**San Joaquin Solar 1 & 2 Hybrid Project
Supplemental Information
In Response to CEC Data Adequacy Requests
08-AFC-12**

TECHNICAL AREA: AIR QUALITY

Figure 5.5-5 - General Hydrogeologic Conditions

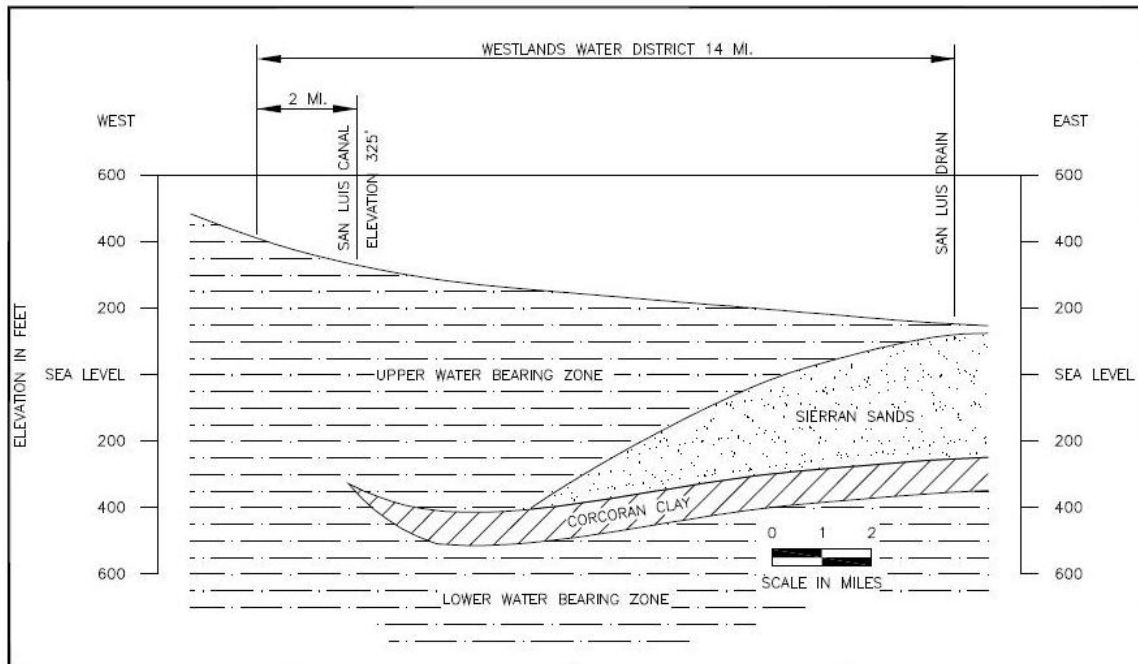
Data Adequacy Request 2: Please provide figures depicting hydrogeologic conditions, groundwater bodies or related geologic structures.

Response: Figure 5.5-1 in the AFC presents the groundwater sub-basins in the vicinity of the project. Figure 5.5-5 (new figure) taken from Westlands Water District report entitled "Deep Groundwater Conditions Report," dated March 2008 (available online at: www.westlandswater.org/short/200805/525r07.pdf), presents a general hydrogeologic condition of the valley adjacent to Coalinga within the Westlands Water District. This report, available from Westlands Water District, provides general hydrogeologic conditions in the area. The project is located several miles west of the San Luis Canal as depicted on Figure 5.5-5. The existing onsite well (as currently screened) likely draws water from both the upper and lower water bearing zones. More detailed hydrogeologic conditions at the site will be provided along with the aquifer test results. Note that the project is located within the Pleasant Valley Groundwater Sub-basin and Water District (west of Westlands Water District), so the information provided in the Westlands Water District report, while informative in a general sense, may not reflect actual conditions within the Pleasant Valley Water District.

FIGURE 5.5-6 - GENERAL SITE GRADING

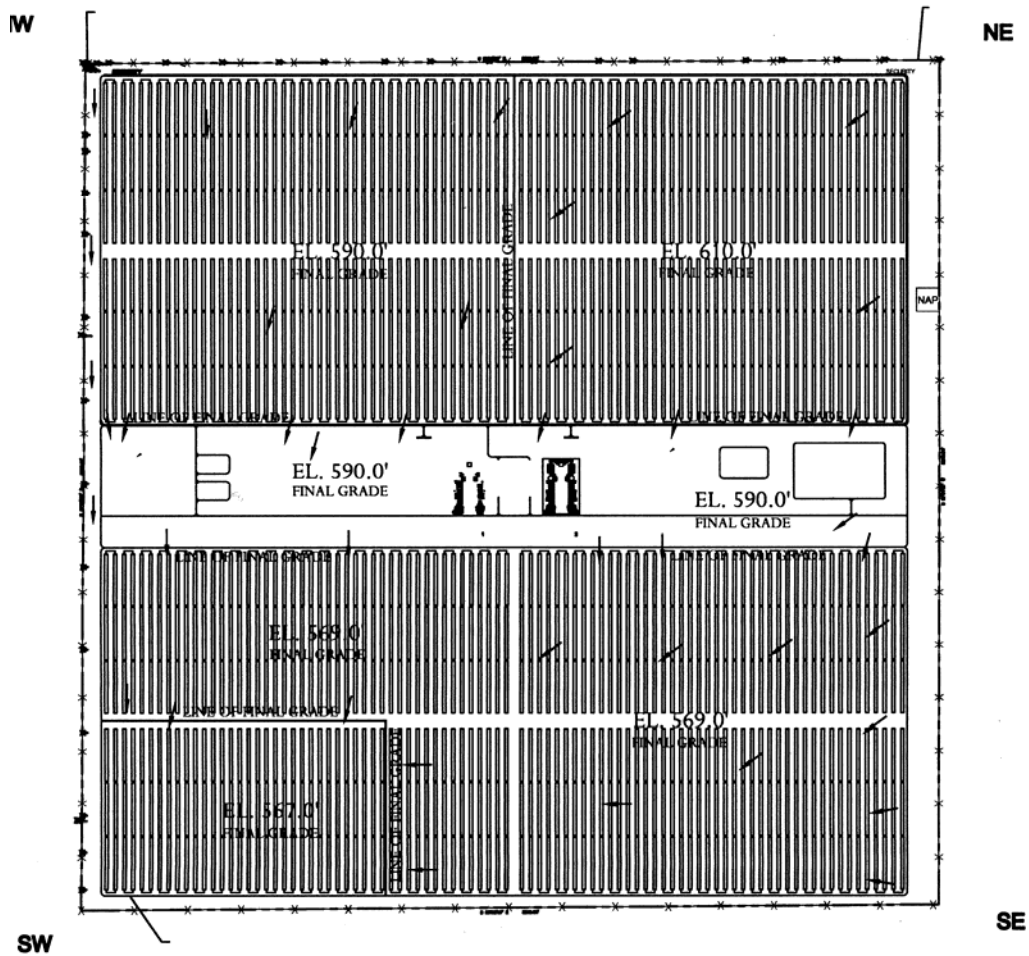
Data Adequacy Request 9: Please provide a description of design storm. Need storm water collection system design, storm water collection system description and storm water collection system diagrams.

Response: The onsite stormwater conveyance systems will be designed in accordance with the Fresno County drainage standards for swales, pipes, infiltration basins, etc. Fresno County has a draft hydrology/hydraulic design manual that will be utilized to design and protect facilities from damage from 100-year flooding.

The currently proposed design will sheet flow accumulated runoff through each of the four main pad areas. Flows may be concentrated at select locations including: roadside swales, road cross culverts, terrace downdrains, and at the entrance to the infiltration area in the southwest corner of the site. The infiltration area will be designed to accept and infiltrate annual runoff volumes to reduce post project flows to at or below existing levels. Accumulated runoff that cannot be stored and infiltrated will be discharged out of the basin in a controlled method to prevent erosion at the outlet and receiving water. Figure 5.5-6 (shown below) shows the general pad grades (610 feet in the northeast quadrant, 590 in the northwest quadrant, 590 in the powerblock area, 569 in the southeast and southwest quadrants, and 567 within the southwestern infiltration area), general flow directions and location of the infiltration area in the southwest corner of the site.
